EXHIBIT B

These following Attachments will set forth, for the record, specific responses to the various prior art references set forth by the examiner, Jennifer E. Winstedt, in the Detailed Action mailed on April 4, 2001.

Attachment XII Re: Claim Rejections of Nos.1-4, 2nd Detailed Action

Attachment XIV

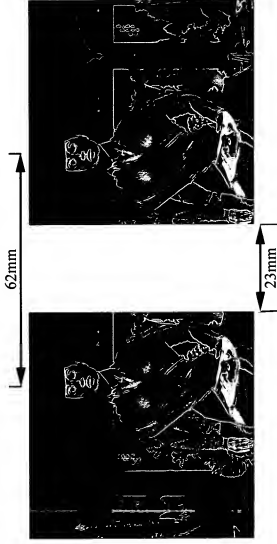
This image is produced to the specific dimensions required and designated by the Kono patent; it is based on the usage of 120mm Medium Format film as designated (Kono, JP63-8624, page (3)-119-, column 1, line 26). The image can be "free viewed" i.e., viewed free of the use of a viewer, directly from this page.

Upon fusion, one will see five fields: a central stereo field flanked by left and right monocular fields, and two outer fields typical of the "Three Picture Effect". Note that each of the fields is divided by a sharp line and that the three central fields do not merge and blend together seamlessly, and cannot be made to do so. As shown here, it is evident that the monocular fields do not occupy a peripheral visual position.

One will also observe that the left and right monocular fields are very unsteady and waver in and out of visibility, and that the proportional area of the central stereo field is very narrow. These problems are inherently derived from the placement of the 23mm gap between the left and right stereo images.

The 23mm gap and the 62mm picture center dimension are specified in the text (Kono, JP63-8624, page(3)-119-, column1, lines 30,31,37,38; column 2, lines 31,32) and drawings (See Kono, JP63-8624, Fig. 6: "B = 62mm", Fig.8: "62mm, 23mm") of the Kono patent; and are absolutely necessary to enable the Kono method to function. The gap provides a clear space for the two monocular fields to be viewed together with the central 3D field. The placement of said gap and proportion of the stereo and monocular fields does not teach an obvious use of or combination with a viewer with adjustable lenses and adjustable occluding apertures. The Kono method exclusively teaches the specific use of the 23mm gap and said field proportions to achieve quite the opposite, a format that can be free viewed or viewed with a standard magnifying viewer with no occluding apertures, but with a sacrifice of image quality, as can be seen here.

Attachment XV After Fusion: The Kono Stereo Image Format (Re: No.6)

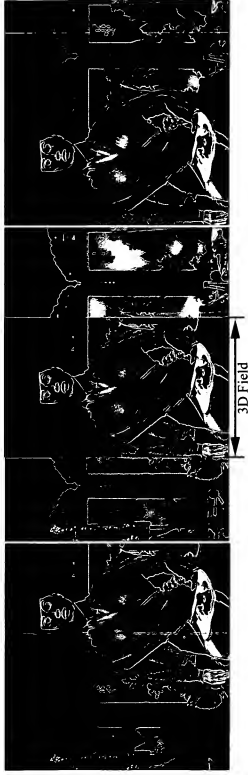
For those who find it difficult (or impossible) to successfully fuse and perceive the example provided with Attachment XIV, here is an accurate simulation of the Kono stereo image format as seen after fusion. It should be understood that the central image field (See arrows) would be in 3D, and that this simulation does not convey the 3D aspect, but is useful for indicating the configuration and proportions of the fields of the Kono image format after fusion.

One will notice that the proportions of the Kono central 3D field are very narrow, and that the monocular fields are lighter in tone than the central 3D field and they also tend to pulse and fluctuate when actually viewed. Note the distinct sharp line which divides the central 3D and monocular fields, i.e., the fields do not blend seamlessly. Note that the outer residual images due to the "Three Picture Effect" occupy the most peripheral visual positions, not the monocular fields. All of these problems hinder the quality of this image format. As shown here, this is not an immersive image format.

The 23mm gap is the reason the Kono method works, but it is also the reason for the stated problems. The 23mm gap deprives the central stereo field of 23mm of fusible optical space, i.e., the specific designated constraints of 62mm for the spacing of the stereo image center points (Kono, JP63-8624, page (5)-121., Figure 8, Page (3)-119., column 2, lines 28-32) determines the size of the central stereo field. Without the gap, the stereo field would be 62mm wide.

With the gap, which allots clear optical space for the monocular fields, the central 3D field becomes only 39mm wide.

The monocular fields are lighter than the central 3D field because one's vision is fusing the monocular fields but also the white page space of the 23mm gap, since there are no adjustable occluding apertures to occlude this extra light. This tonal disparity causes the sharp dividing line between the central 3D and monocular fields, and also because the sharp edges of 23mm gap are in the same focal plane as the image.

Actual Size of Immersive Image Page Format of the Present Invention (Re: No.6)

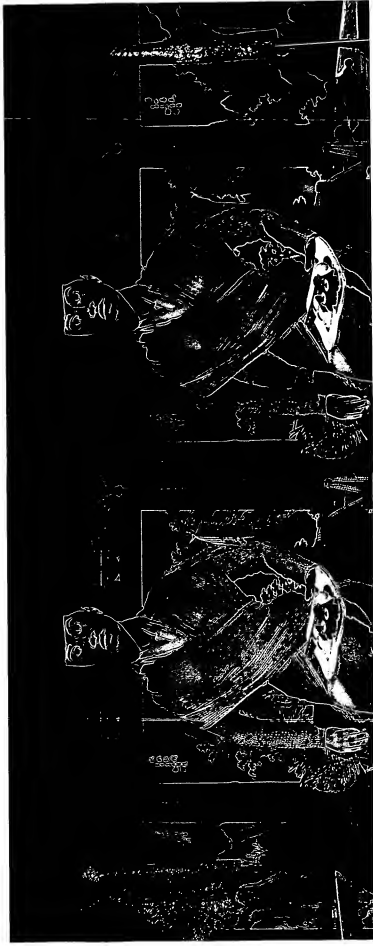
Shown here at actual size is an example of the latest Immersive Image page format for the present invention. The same subject matter is used, to enable comparisons of these image fields to be made with the image fields of the Kono wide-angle format, which is also shown at actual size.

Please note that this image format is not designed to be free viewed. It is configured to be viewed with the means of the present invention only, which utilizes the prism capabilities of the optics to enable perception of stereo image fields with image centers beyond the 62mm distance of the average interpupillary distance. Note that there is no 23mm gap between the left and right images. These two stated factors enable this format, when used in concert with the means of the present invention, to convey a truly immersive visual image field that simulates human vision.

Before Vision: The Three Image Formats Sized for Free Viewing (Re: No.6)

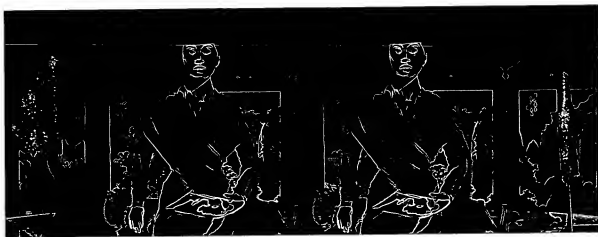
Perhaps the most simple and elegant way to see the distinctive differences between the three image formats is to free view all three together, with the exact same content, so an accurate comparison can easily be made. Please note that the top image format shown here of the present invention, is **greatly reduced from its actual size that would be used in the present invention** (see Attachment XVI for the actual size of the format), and that the format is not designed to be free viewed, but only to be viewed with the means of the present invention.

The middle image format provided here is the Kono wide-angle format, and it is stressed that it is shown here at actual size, as it is designed to be free viewed, with the centers of the stereo images set at 62mm, and the 23mm gap used to provide an optical space for the left and right side monocular fields to exist next to the central 3D field.

The bottom image format shown here is the traditional 19th Century stereograph format. It has been reduced slightly to make it easier to free view. There are no unexpected results here, just the typical "Three Picture Effect".

Attachment XIX After Fusion: Distinctions Between the Three Image Formats (Re: No.6)

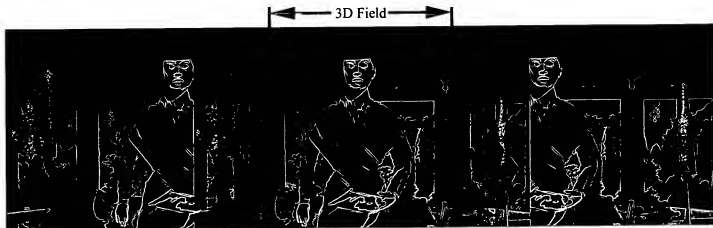
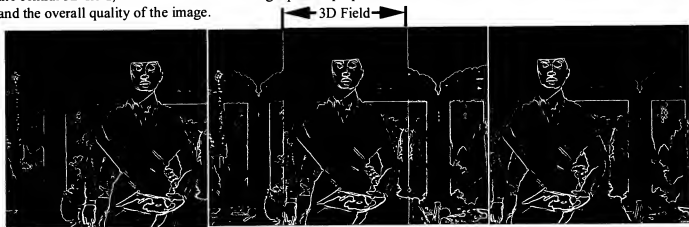
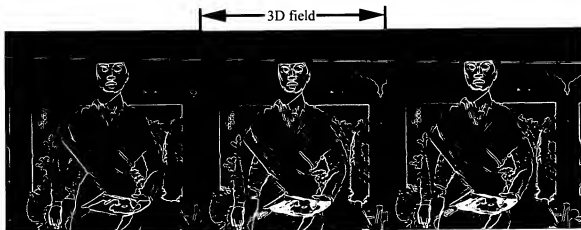
At the top is the immersive image format of the present invention. Remember that it is not designed to for free viewing, although the central field would still appear in 3D in this instance; however, as shown here, the peripheral fields overlap the residual fields and cause a "double exposure" on each side of the central 3D field. This problem is eliminated when the image format is properly viewed with the means of the present invention.

Note that the Kono format is designed to be free viewed, and that the 23mm gap enables the side fields to exist next to the central 3D field, to create a more wide-angle picture proportion, but with a sacrifice to the width of the 3D field, and the overall quality of the image.

The bottom example is the traditional stereograph format, which produces the "Three Picture Effect".

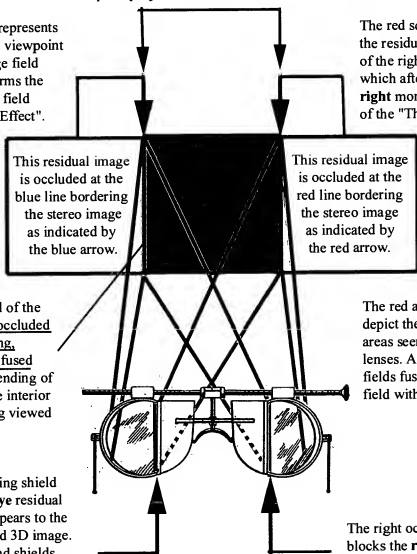
The red square area represents the residual **left-eye** viewpoint of the right stereo image field, which after fusion, forms the **right** monocular image field of the "Three Picture Effect".

This residual image is occluded at the blue line bordering the stereo image as indicated by the blue arrow.

This residual image is occluded at the red line bordering the stereo image as indicated by the red arrow.

This occlusion is typical of the devices of the era. The occluded edges are at the bordering, non-image edges of the fused stereo image, and no blending of peripheral content in the interior of the overall field being viewed is required.

Scanning Capability Diagrams (Re: Claim Rejections of No.7)

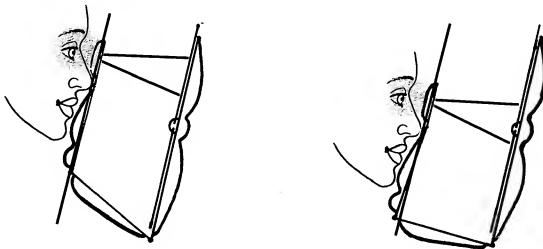
If the chassis of the embodiment from patent 5,499,136 is positioned incorrectly in an attempt to enable a scanning motion while keeping the viewer in the lens-to-image plane, the chassis section below the viewer pushes against the user's lower face, and thus, the user cannot get their pupils close enough to the lenses (see yellow area below) to see the content, because the cone of vision is greatly reduced. This problem also effects the ability of the occluding apertures to blend the peripheral and central fields properly.

The pivotal geometry of this chassis was never designed to enable the viewer to optically convey two spread pages of content with the function of scanning while maintaining focus.

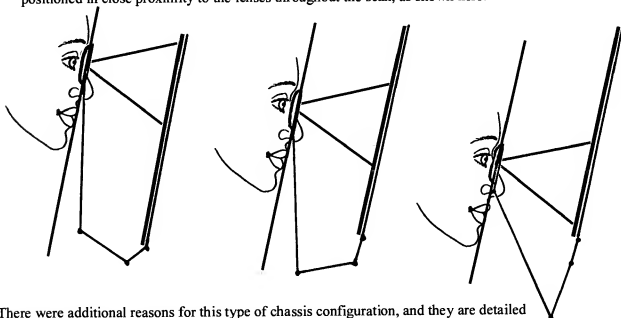
The examiner has misread the prior art of Jones (the said same inventor of the present invention), and mis-attributed to said art the functional capability of the viewer being able to optically convey the content of two spread pages by visually scanning up and down said content while maintaining focus. As shown here, the content **cannot** be adequately conveyed due to the geometry of said prior art chassis.

The Viewer Pivotal Chassis of the present invention is expressly configured to enable the viewer to scan up and down a length of content while maintaining focus. The pivotal geometry of the chassis enables this operation to be achieved in one scanning motion, and the user's eyes are correctly positioned in close proximity to the lenses throughout the scan, as shown here.

(Figure 2.)

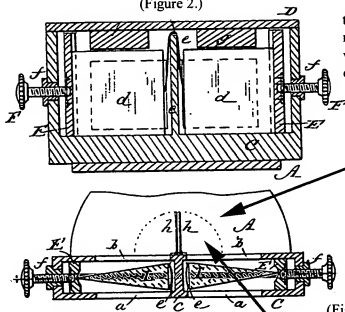
This is the other position (called "pressed flat" - Stevens) of flaps "h". Note that the flaps **do not slide** in a plane parallel to the plane common to the lenses, as do the occluding apertures of the present invention.

As was stated in Attachment VII of the 1st Response, these types of septum devices were designed to block the user's perception of the "Three Picture Effect" and **do not disclose or teach** the functional capability of precisely blending three fields of content together to create an overall immersive field. **It is impossible** for the lenses and flaps of the Stevens device to do this, no matter how they are adjusted.

Flaps "h" are not configured to be **gradually adjustable** in relation to the lenses while viewing immersive content, or any content for that matter.

As shown here, from Figure 2.

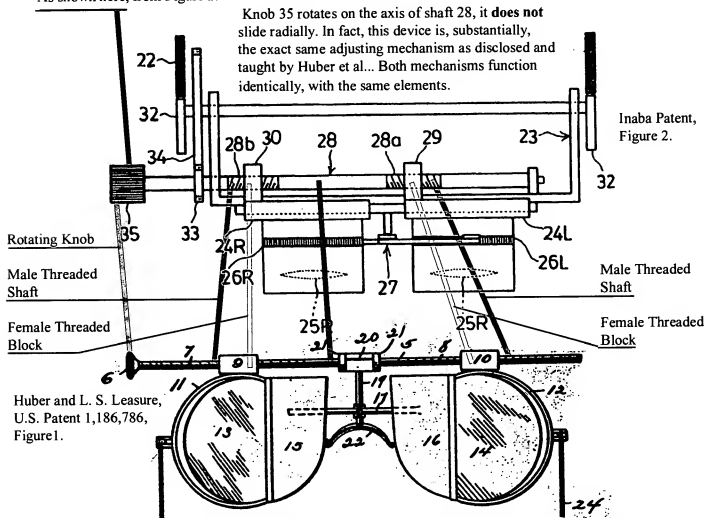
Note: it seems the examiner failed to look at the Figure 2 Top View in the Inaba patent which reveals the means of adjustment clearly, and also failed to note Figure 2 in the Detailed Action, and stressed that Figure 1 be seen.

Knob 35 rotates on the axis of shaft 28, it does not slide radially. In fact, this device is, substantially, the exact same adjusting mechanism as disclosed and taught by Huber et al... Both mechanisms function identically, with the same elements.

It is ironic that the examiner has misread the Inaba patent and attributes knob 35 to Inaba, when this is actually part of a "known" pre-existing camera which Inaba is seeking to improve. It's also ironic that the examiner fails to see the exact functional similarities of this camera's interocular adjustment device and the Huber et al. device. On page 13, it seems the examiner does not recognize said device as being the same as Huber et al., and instead is citing Inaba as a reference that teaches the function of a "sliding adjustment switch" with knob 35, as disclosed in Figures 29, 36-38 and required in Claims 34-36 of the present invention, which all slide in a linear direction. As shown above in Inaba Figure 2, turning knob 35 rotates threaded shaft 28. In Figure 1, Huber et al., turning knob 6 rotates shaft 5. They are alike. The examiner has misread said Figures and attributed functional capabilities to the reference that are not disclosed or taught therein. The examiner has also misread Figure 4 of the Inaba patent, as shown in the next Attachment.

FIG 4

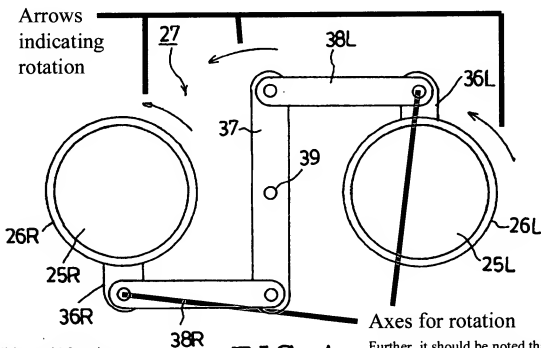
The Inaba device, as shown here, **does not move said means or any means towards or away from each other.** Figures 1 and 4 disclose and teaches a pivotal arm that **rotates** the stop mechanism of each camera lens in a synchronized motion.

This is clearly demonstrated in Figure 4, which indicates with arrows the direction of rotation of the arm and the lens stop rings, which can be seen more clearly in the Top View of Figure 2 in the preceding Attachment.

In addition, said function of this mechanism is clearly designated in column 4, lines 64-68, and column 5, lines 1-40 of the Inaba patent.

(Figure 6.)

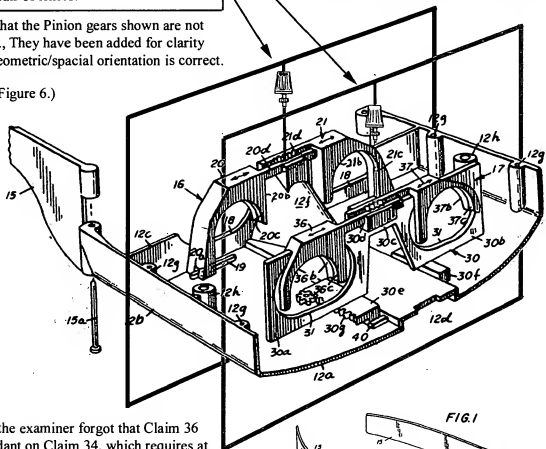
As can be seen here, the rotational axis of each respective pinion gear exists in a plane that is **common, not perpendicular** to the same plane that is common to the left and right lens of each respective pair of lenses.

It is noted that the Pinion gears shown are not in Figure 6., They have been added for clarity and their geometric/spacial orientation is correct.

In No. 12, the examiner forgot that Claim 36 was dependant on Claim 34, which requires at least one sliding adjustment switch to facilitate rapid and precise interocular adjustment of the merged lenses and occluding apertures.

Attachment XXX Frantz & Joseph Prior Art (Re: Claim Rejection of No.12)

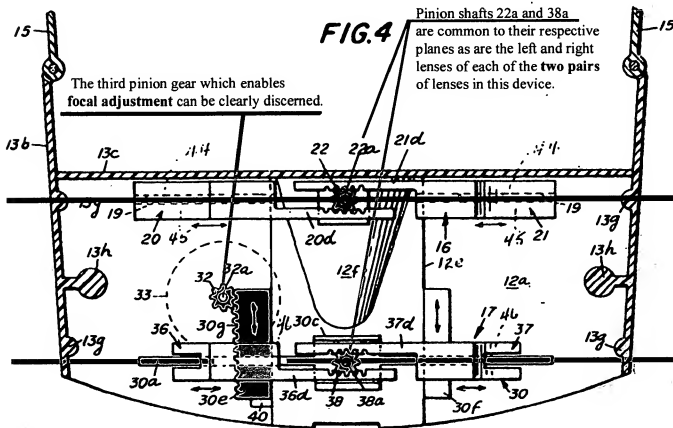
Shown here is Figure 4 of the Frantz & Joseph patent, as cited by the examiner. Figure 4 is a Top View; and the two planes (blue and pink) shown in the previous Attachment are now seen from an angle that clearly reveals how the left and right lenses of each pair are common to each respective plane, and the pinion shaft provided for each respective pair of lenses is also common to each said same respective plane. The shaft i.e., the rotational axis of each respective pinion gear is not perpendicular to each said plane.

In No.12, page 15, line 5, the examiner states it would have been obvious --- "to include a pinion gear meshed with first and second linear gears as Frantz et al. suggests in order to allow for interpupillar spacing of the lenses so *there is always a visual path through the viewer* (Frantz, column 1, lines 62-64)..."

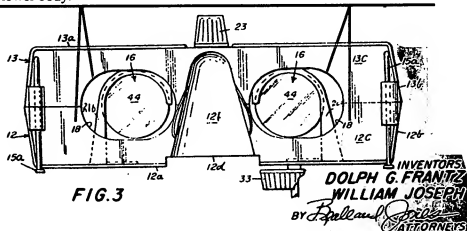
The lines in the Frantz & Joseph patent the examiner cites **do not** pertain to "a pinion gear meshed with 1st & 2nd linear gears", the lines cited (in *italics* above) actually pertain to the "ovallike" shape of "eye apertures 18", which are simply the eye holes in the rear of viewer body:

It should be understood that Frantz et al. uses the term "aperture" in its most common definition, to describe a hole. The term "aperture", as used in the present invention with the term "occluding aperture", is used to define the functional capability of an aperture that works like an aperture in a camera, as a means to precisely control the passage of light.

FIG. 36

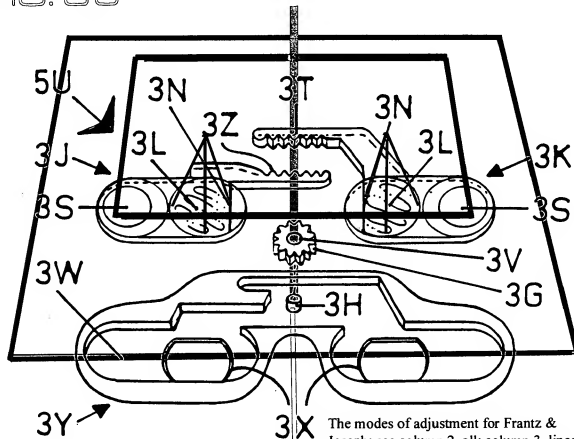
Shown here is Figure 36 of present invention, which pertains to Claim 36. The Frantz & Joseph patent does not disclose or teach a device which uses a single large pinion gear meshed with two linear gears, with, as states Claim 36: "a rotational axis of said pinion gear being perpendicular to a plane that is common to the left and right lenses. There are at least three parallel planes that can be considered common in the traditional geometric definition: a plane (in green) that the disk-like bodies of the lenses share in space, which would be the most widely accepted definition of "a plane that is common" to the two lenses; however, two other planes that are common optically to the lenses is an image-to-lens plane (in orange), a plane in which the content is seen in focus, and the typical focal plane determined by the back focal length convergence point of the lenses (in purple)

If at least the additional reference plane of the focal plane of the Frantz & Joseph device is considered, the pinion gear shafts (i.e., axes) of the device would be **parallel** to said focal plane, **not perpendicular**.
